CHANGE DESCRIPTION (FROM/TO) -- continued:

Parts needed for this change:

Heatsink:

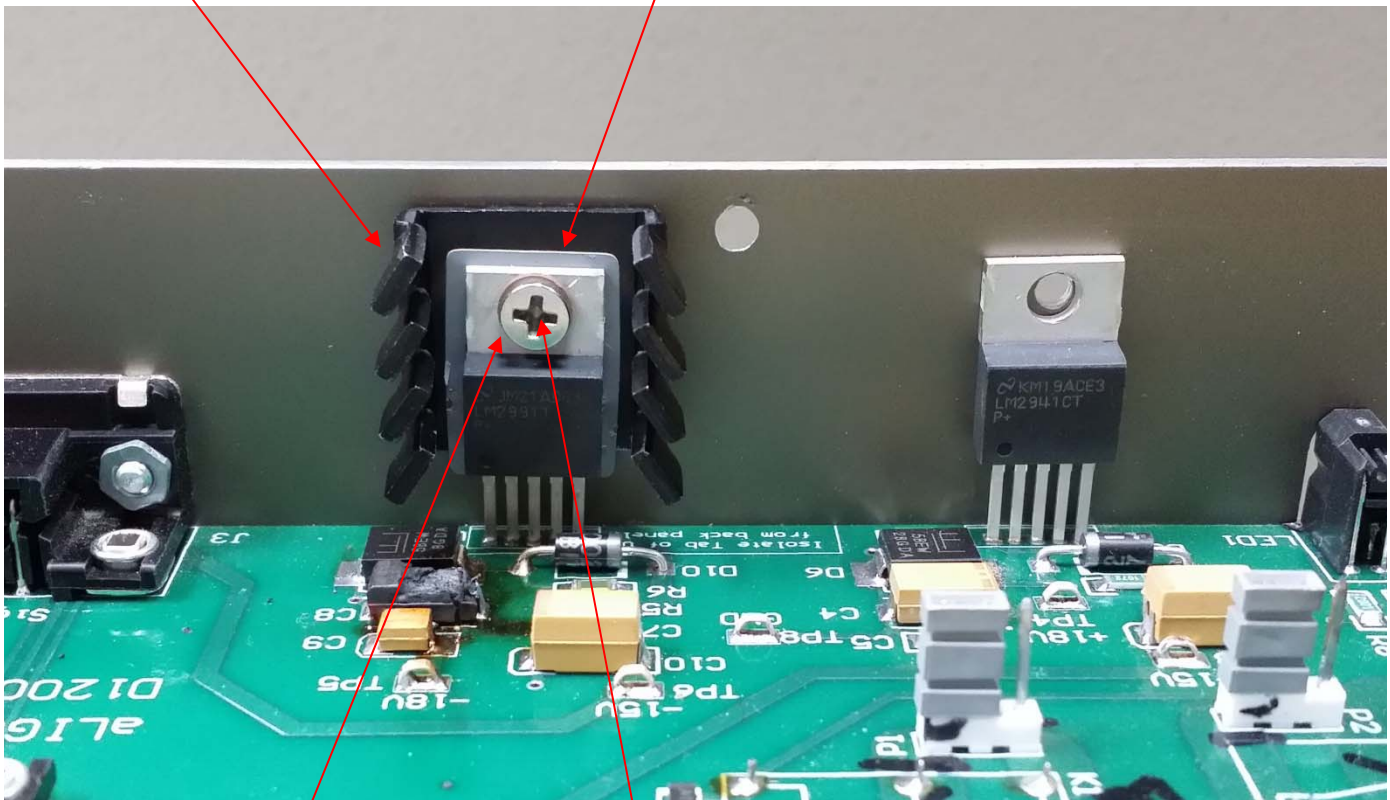
Qty.1) A10762-ND (Heatsink)
